Carolina Power & Light Company

SERIAL: NLS-84-051

BRUNSWICK STEAM ELECTRIC PLANT, UNIT NOS. 1 AND 2  
DOCKET NOS. 50-325 & 50-324/LICENSE NOS. DPR-71 & DPR-62  
ELECTRICAL DISTRIBUTION SYSTEM VOLTAGES

Answers to Request for Additional  
Information Dated September 1, 1983  
Question 7, 8, and 9

SKETCH 1

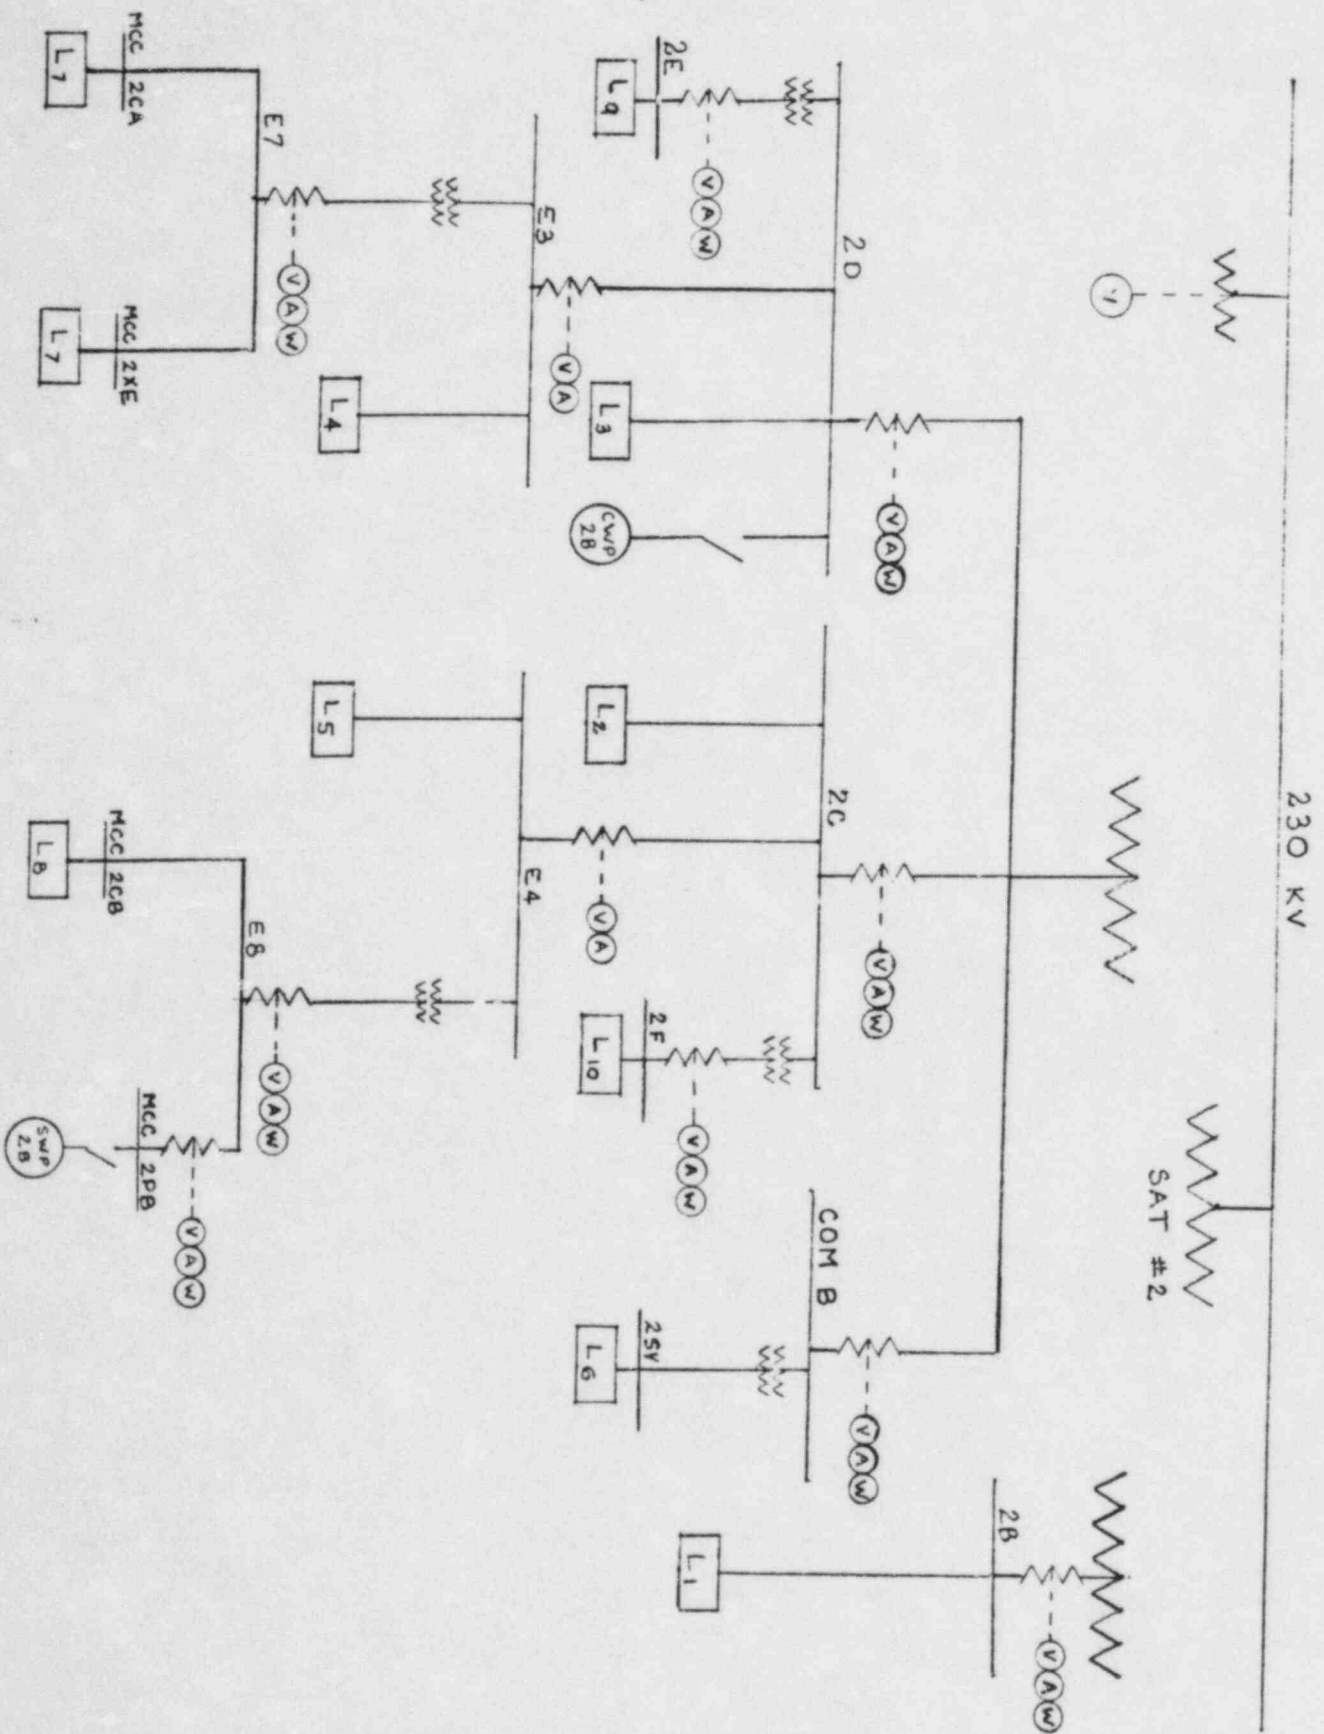
Demonstrate that the test measurements and test analysis were for identical station electrical loading.

The BOP and emergency bus loads were fed from the startup transformer No. 2. At the time of the test, the power generator was 40% of the rated capacity of each unit and the following major loads were running:

The above station loads were measured at the same time (15:48 p.m., December 12, 1980) at various locations as shown on Sketch 1.

For test analysis, megawatts were taken directly from site test data and megavars were computed (see Appendix A of the study report) from megawatt, voltage, and current data with the exception of motor starting loads noted in Response 8.
